HMA RESURFACING / HMA PAVED SHOULDER - NEW

IA 78 FROM WINFIELD E. TO US 61

FIELD EXAM NOTES:

All three projects were discussed during the same 4/7/2021 Field Exam Meeting.

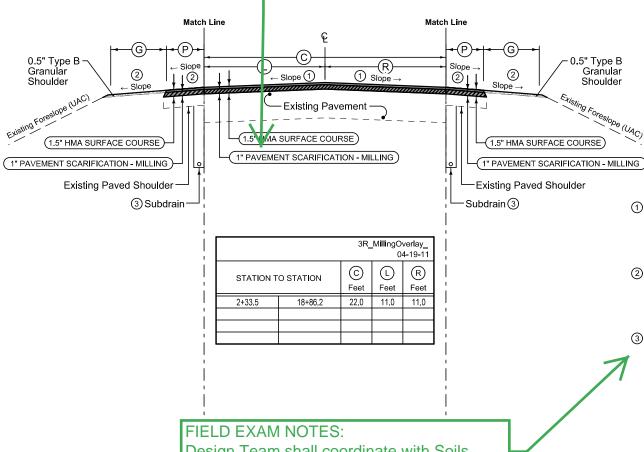
District 5 Maintenance Team agreed to stockpile HMA Millings (or Class A Stone).

Design Team shall coordinate with Soils Bureau for design of proposed subdrain.

IA 78 WIDENING/HMA RESURFACING

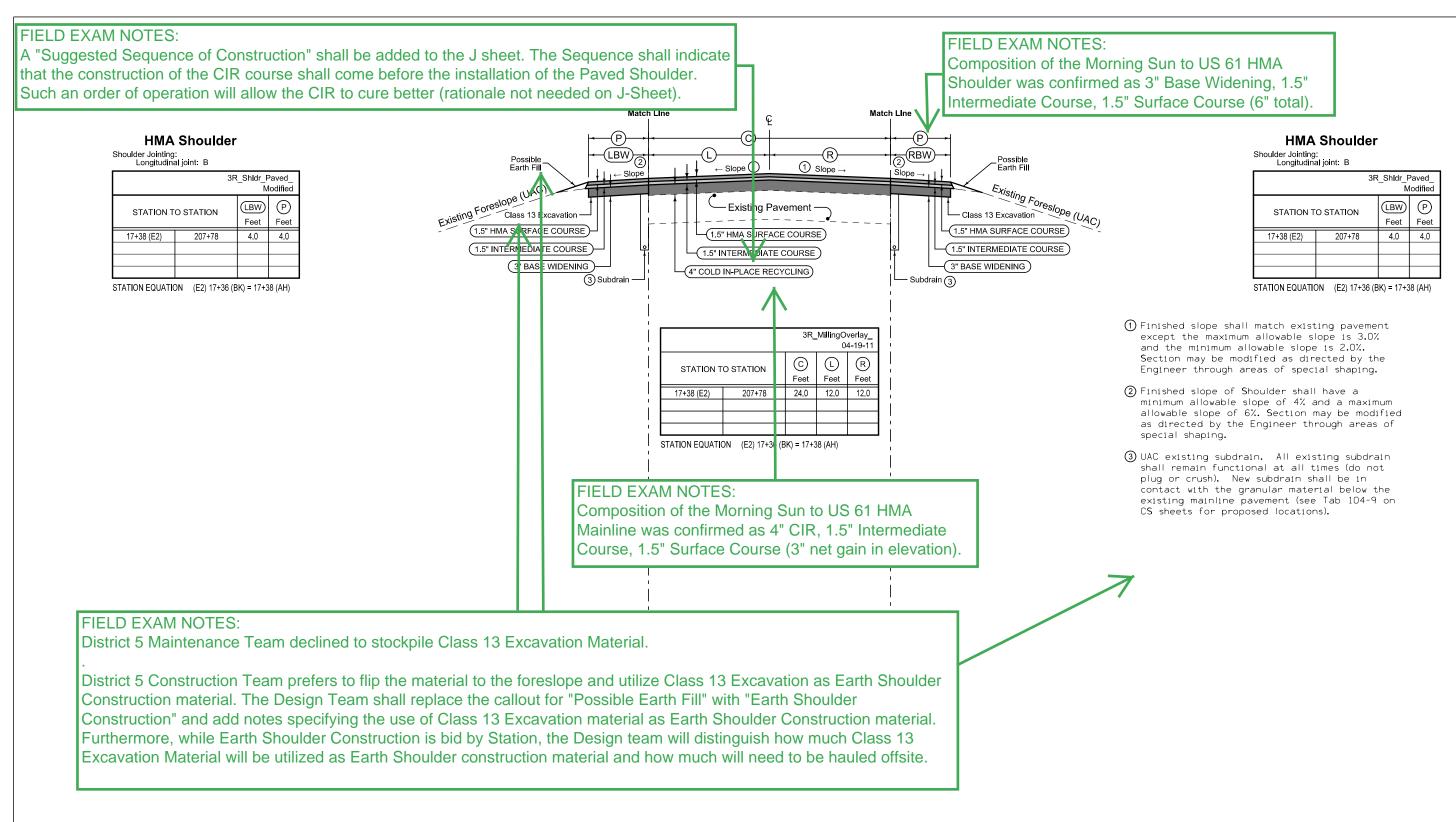
This project will utilize Rumble STRIPES to provide additional space for bicyclists on the shoulders. Rumble Stripes shall NOT be utilized within the Corporate Limits of Winfield and Morning Sun.

Multiple Pavement Marking applications of edgeline will be added to accommodate sequence of final surface construction and subsequent installation of Rumble Stripes.

The Project Concept says "1" HMA Interlayer, 2.5" leveling/strengthening course, plus a 1.5" Standard HMA." for Section 3 (Winfield to Morning Sun) The Design Team asked the District if the 2.5" leveling/strengthening course should be identified as a "Scratch Course" and be placed beneath the interlayer since the existing pavement in this section (IA 78, Winfiled to Morning Sun) is PCC.

Jim Phillips (District 5) confirmed in a 4/7/2021 e-mail at 1:28pm the following sequence (from existing pavement surface up): 2.5" Scratch Course, 1" Interlayer, 1.5" Surface Course. This is because the existing pavement is PCC. If the existing pavement was HMA it would be 1" Interlayer, 2.5" Scratch Course, 1.5" Surface Course.

A note shall be added to the typical that "Scratch Course consists of a a HMA Mixture Leveling or Strengthening Course" and be bid as 2303-0001000 HOT MIX ASPHALT MIXTURE, WEDGE, LEVELING OR STRENGTHENING COURSE (TON).

IA 78 CIR, HMA Resurfacing, and Widening

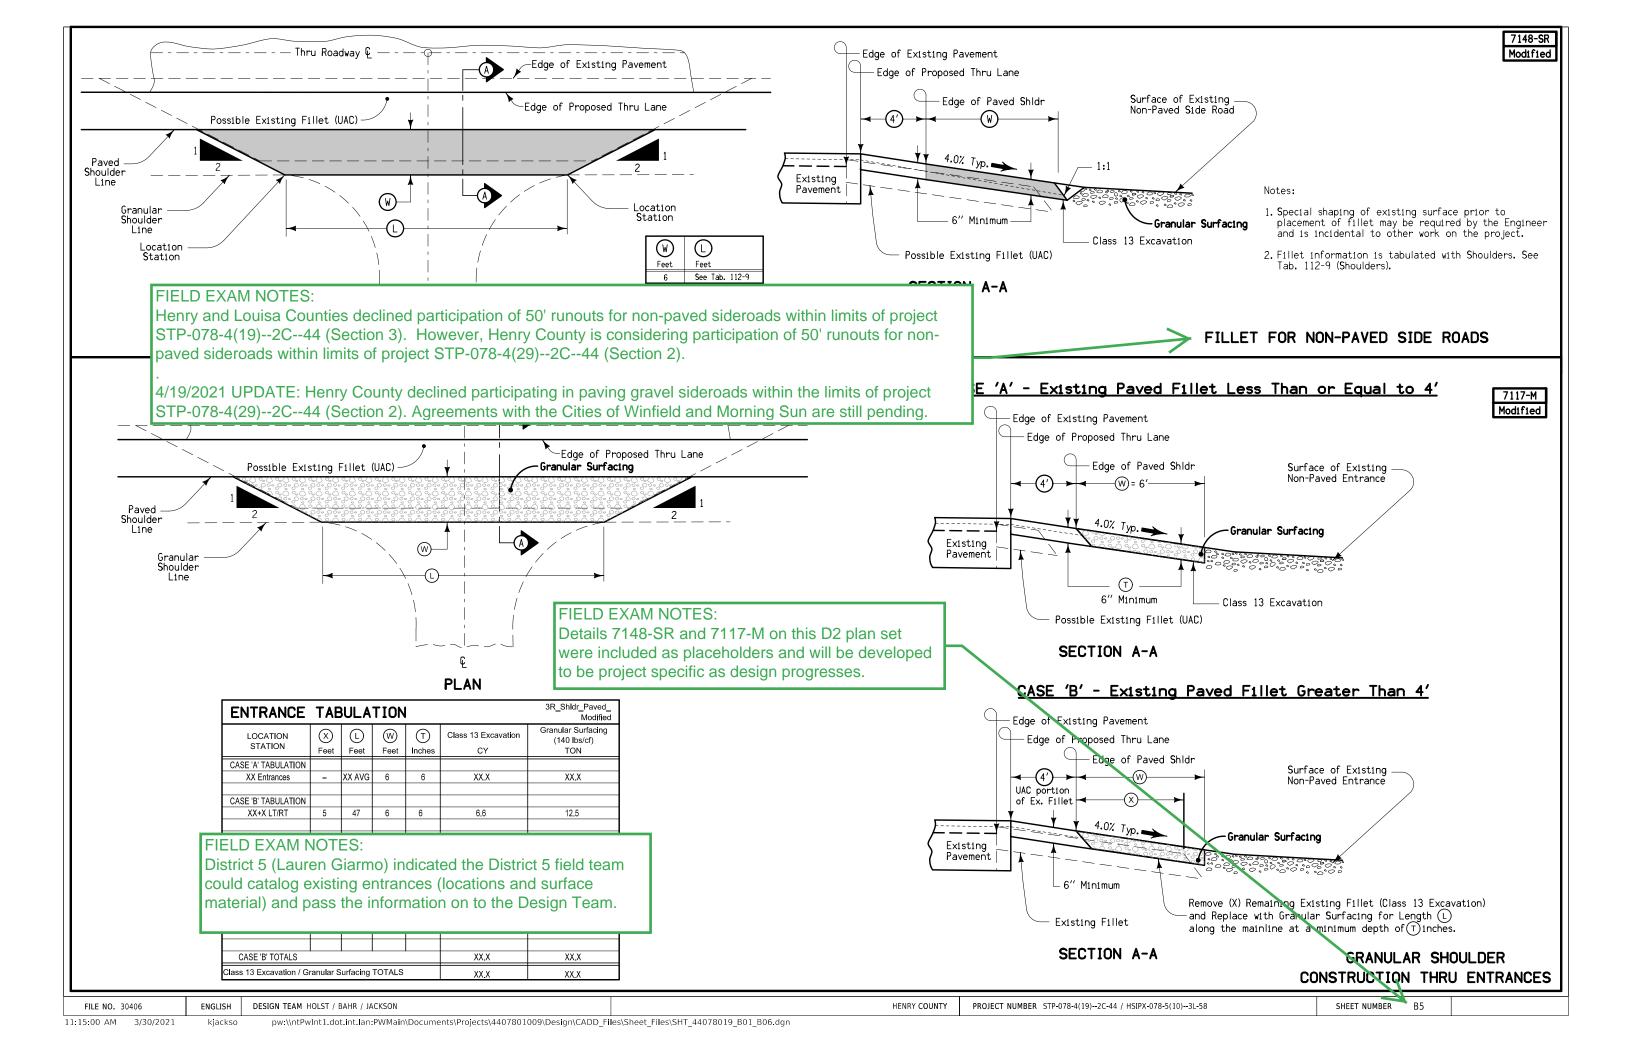
A "Suggested Sequence of Construction" shall be added to the J sheet. The Sequence shall indicate that the construction of the CIR course shall come before the installation of the Paved Shoulder (see Morning Sun to US 61 typical on Sheet B3). Such an order of operation will allow the CIR to cure better (rationale not needed on J-Sheet).

PAVED SHOULDER AT GUARDRAIL (ADJACENT TO PARTIAL WIDTH PAVED SHOULDER)

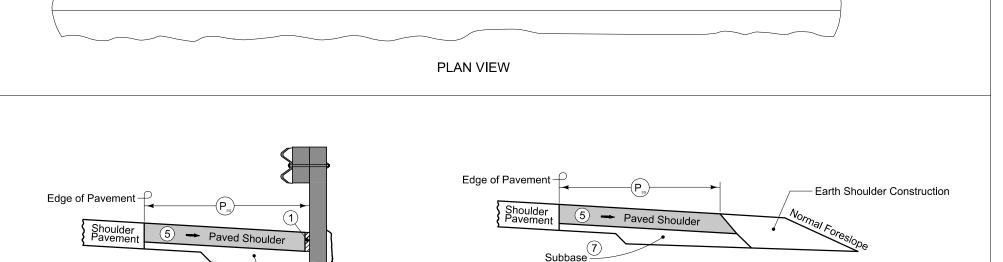
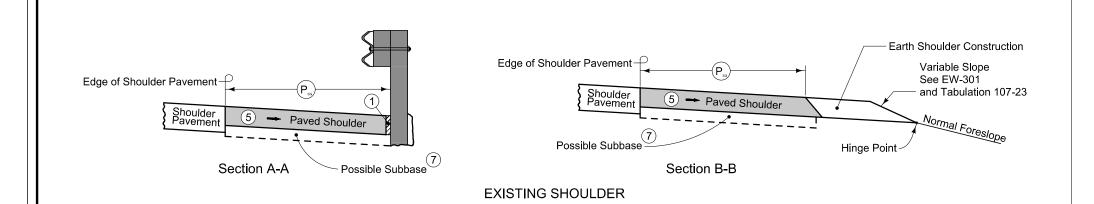
District 5 Maintenance Team declined to stockpile existing guardail beam and posts that are being removed.

Detail 7157 on this D2 plan set was included as a placeholder. Additional "Paved Shoulder at Guardrail" details may be included in subsequent submittals to accommodate the varying conditions found within the project limits.
